Response to referee comment on "Technical note: Turbulence measurements from a Light Autonomous Underwater Vehicle" by Eivind Hugaas Kolås et al., Ocean Sci. Discuss., <https://doi.org/10.5194/os-2021-107-RC1>, 2021

Response to Reviewer 1

Response to Reviewer 2

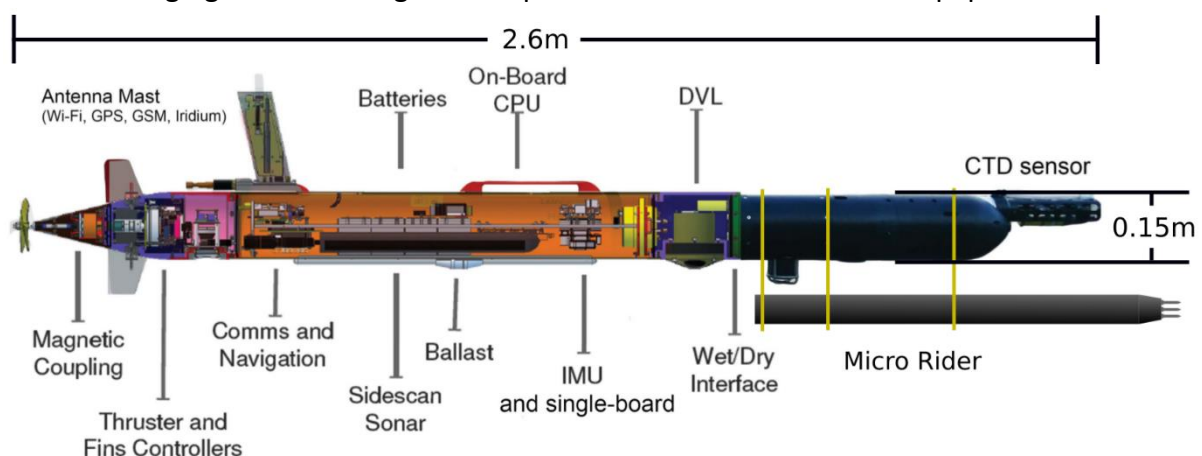
- Particulars about the MR mounting, possibly a drawing.

The following figure illustrating the setup has now been included in the paper.

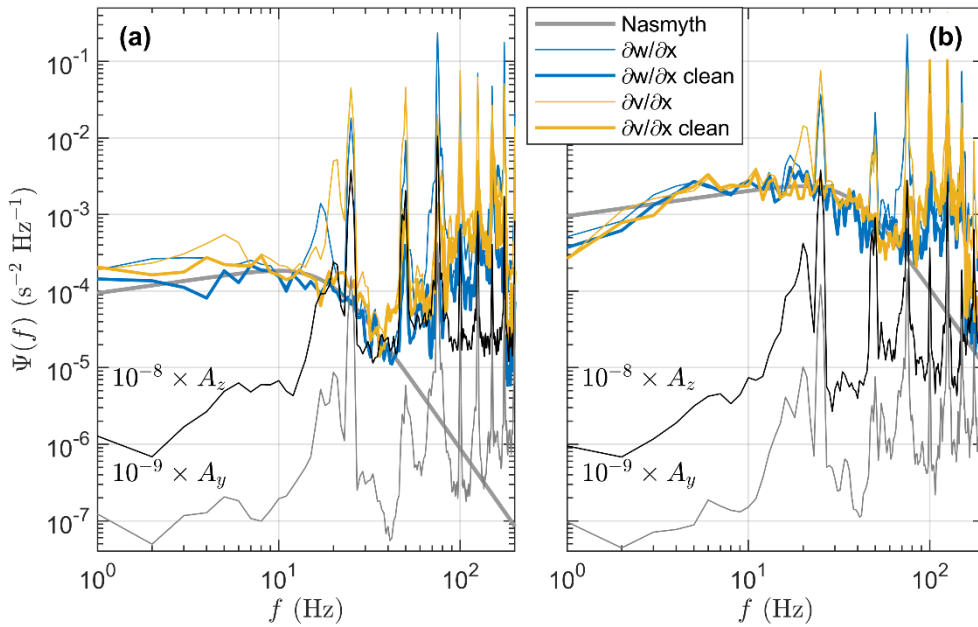
- (L.156) *Is there a criterion why change rates of 10° roll/s, 5° pitch/s, and 2 RPM/s have the same consequence?*

The final screening done here is based on visual control of the time series, where an abrupt rate of change of flight behavior can lead to contaminated dissipation estimates. The chosen thresholds delineated these and are used to remove outliers. We've produced scatter plots of the rate of change vs dissipation and decided on the rate of change thresholds based on those. A change in roll is generally a much smaller disturbance on the shear sensor than a change in pitch (because of how the MR is mounted on the AUV), thus a higher value is allowed. There is no criterion why the different thresholds on the different variables should have the same consequence.

We now specify in the processing description that the thresholds in the final screening are based on visual inspection of the rate of change vs dissipation estimates.

165 when the flow over the shear probe is no longer laminar (Osborn and Crawford, 1980). Final data screening excluded data with rate of change exceeding 10, 5 and 2 units per 1 s for roll, pitch and RPM, respectively. The thresholds in the final screening was determined from visual inspection of rate of change versus dissipation estimates.

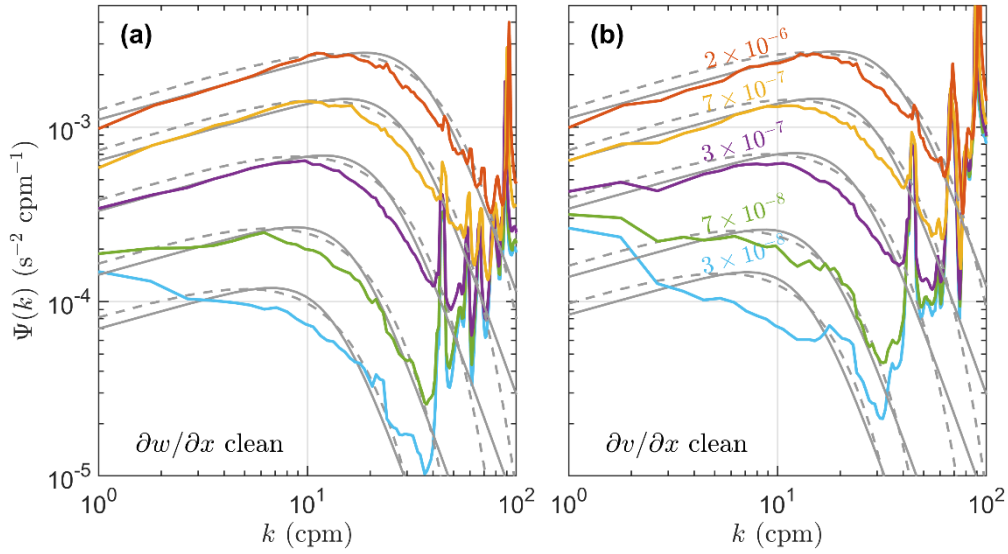
- Fig.5: Suddenly the theoretical Panchev-Kesich spectrum pops up, only in the left panel, without having been introduced before. Its only usage in the paper is in L.218 stating that the spectra resemble both Nasmyth and Panchev-Kesich. However, inspecting Fig.5a, it seems the cleaned spectra fit the Panchev-Kesich spectral shape much better than Nasmyth. (Only the estimated epsilon would result a little lower after a thorough fit.) If so, much of the discussion on early rolloff and spectrum averaging (L.219-224) would be obsolete (L.184 in Results is affected, too). Instead, the interesting question could be discussed why Panchev-Kesich shows the more similar spectral shape.

Thank you for pointing this out. The Panchev-Kesich spectrum is now introduced earlier in the Results section and is now included in both panels of Figure 5 (see attached figure below). In addition, we now produce Panchev-Kesich spectra following the same averaging as for the Nasmyth spectra. In the original version, the Panchev-Kesich spectrum was presented as a reference, plotted using the average dissipation value (hence the roll-off was not smeared out as it would be after averaging over several spectra covering one decade range of dissipation values). Now, the individual Panchev-Kesich spectra (from the individual epsilon estimates) are bin-averaged similar to the Nasmyth spectra and shear spectra. As you point out, the roll-off in our observations does fit the Panchev-Kesich spectra better than the Nasmyth spectra. Yet there is still a systematic offset at the roll-off, and we think this is worth some consideration, hence retain a modified version of the discussion in line 219-224. For wavenumbers between 1 and 10, the Nasmyth spectra fit our observations better for $\epsilon > 1e-7$. A discussion about similarities between our observations and the two spectra is now included (inserted below).

The bin-averaged shear spectra suggest that the most energetic wavenumbers are not fully resolved by our instrumentation; i.e., the transition between the inertial subrange and the dissipation subrange rolls off at lower wavenumbers compared to the similarly bin-averaged Nasmyth and Panchev-Kesich spectra (Figure 6). While the shape of the spectral roll-off is relatively similar to that in the Panchev-Kesich spectrum, the offset between the observed and the theoretical spectra is significant. The bias unaccounted for in application of the Goodman method cannot explain this offset fully. Some of the discrepancies in

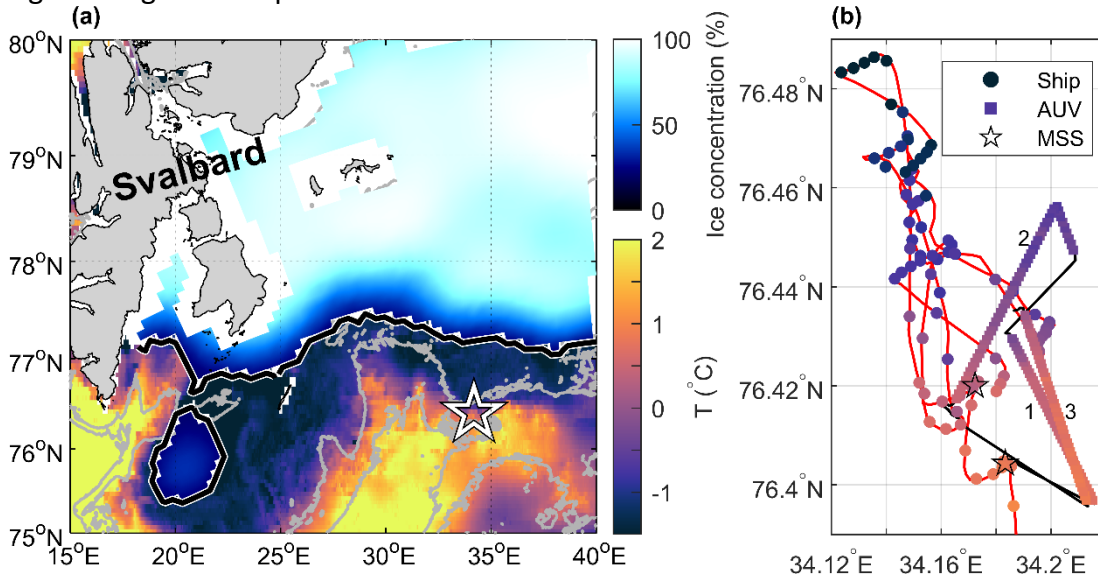
Fig.1a needs more clarity. Isobaths may be negligible. The ice edge is unnecessarily hard to spot, a thicker black line with an overlying dashed white line might be a solution. The experiment location should not be directly on the edge of the plot; expanding to 40°E at least would better support orientation.

Agreed. Figure 1 is updated as shown below.

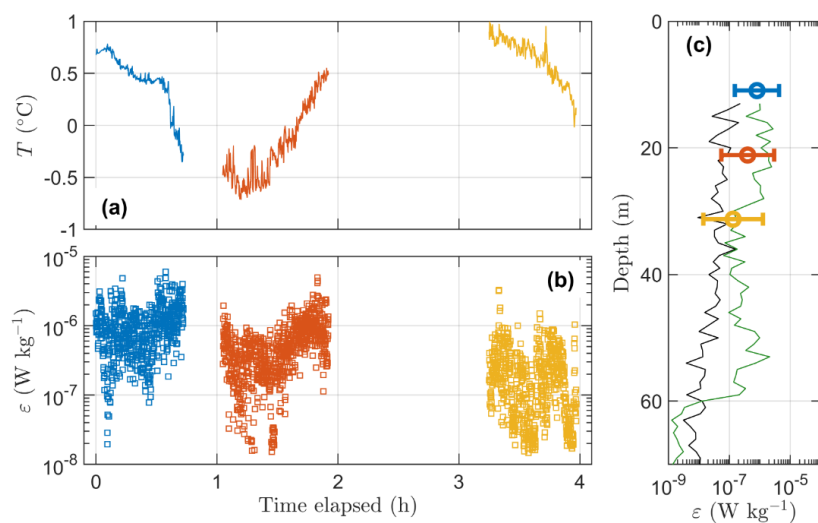
- The comparison between the three epsilon timeseries and the two single vertical MSS profiles (Fig. 7c) seems questionable. AUV epsilon is extremely variable from noise level to very high values of 5e-6. The two MSS profiles differ a factor of about 50, one is near AUV noise level, one is near 1e-6. Trying to compare statistically would mean that we'd have to check the hypothesis if the two MSS values can stem from the AUV epsilon distributions. This hypothesis will certainly not be rejected, but: the question is, which imaginable MSS profiles would be rejected at all? As the basic distribution spans more or less the entire possible range, nearly any MSS measurement would not contradict the zero hypothesis. Two noise level profiles would not; two profiles of 5e-6 would not; maybe two profiles of 1e-5 would have cast doubts. That means that the two MSS profiles probably cannot support the statement 'dissipation from AUV agrees well with MSS profiles' (L.8ff, L.206f, L.247f) in a valuable manner, even if they don't contradict either. I'd recommend to comment the comparison (L.8ff, L.206f, L.247f) more cautious. The MSS profiles might confirm the high variability of epsilon in the region, and they might constrain the uncertainty of the AUV measurements to a factor of 5 or 10.

L.204: 'maximum likelihood estimate': the arithmetic average should do. Or is this what you mean?

Thank you for addressing this. We agree with you on all accounts. The only way the two MSS profiles could potentially contradict the zero hypothesis is if they were off by a factor of 50 or more on the low epsilon side (say both profiles estimated 1e-8), suggesting the region was not as turbulent as the MR measured. We have rewritten this comparison, and now make sure to point out the shortcomings of such a comparison in the results (inserted below).

smaller at greater depth, which is expected in the boundary layer. The arithmetic mean (including 95% confidence intervals)
225 of the natural logarithm of the dissipation rates along the horizontal transects are compared to vertical microstructure profiles (Figure 8c). Although the spatial variability of ε is known to be large (Yamazaki et al., 1990), the vertical profiles and the horizontal transects show comparable dissipation rates. Note however, that the comparison between the two MSS profiles and the average dissipation rates must be interpreted with cation. The two MSS profiles differ by one order of magnitude, enveloping the AUV-based measurements, and cannot be used to statistically test the validity of the AUV measurements.

We used the maximum likelihood estimate but have now changed this to the arithmetic average as suggested (inserted below). Note, we used the arithmetic mean of the natural logarithm of the dissipation rates, which is the same as the geometric mean of the dissipation rates.
